STANDARDS ALERT

OCTOBER 31, 2022
003C2B-SA-019

VA's SPS and Logistics Service Design Guide, Digestive Diseases and Endoscopy Svc. Design Guide, HVAC Design Manual, and Master Specifications Section 08 56 19

Example image of a Pass-Through Automated Endoscope Reprocessing Unit

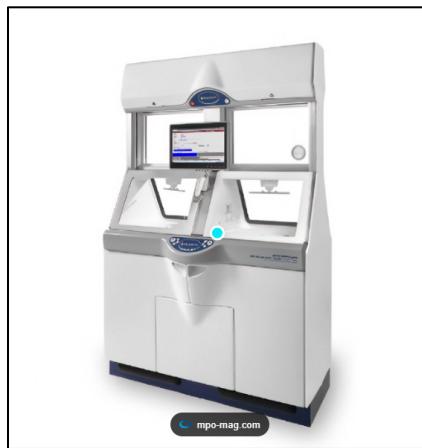
- 4) **Incorporation of new Pass-Through Automated Endoscopy Reprocessing (AER) technology:** Diagram 3.2 has been added to the updated SPS Design Guide to reflect Pass-Through AERs in the sterile processing workflow. The use of Pass-Through AERs eliminates the need for a scope reprocessing room as shown in Diagram 3.1. The Pass-Through AER allows for the scopes to go through decontamination, be reprocessed in the Pass-Through AER and transferred directly into the Scope Staging room. This Standards Alert provides a sample image in **Attachment A** of a standard model. Manufacturer specifications and site requirements may differ depending on the model unit selected or needed.

There are various manufacturers of Pass-Through Automated Endoscope Reprocessing Units available on the market. Facilities must review and follow the manufacturer specifications and site requirements as they may differ depending on the manufacturer and model unit selected.
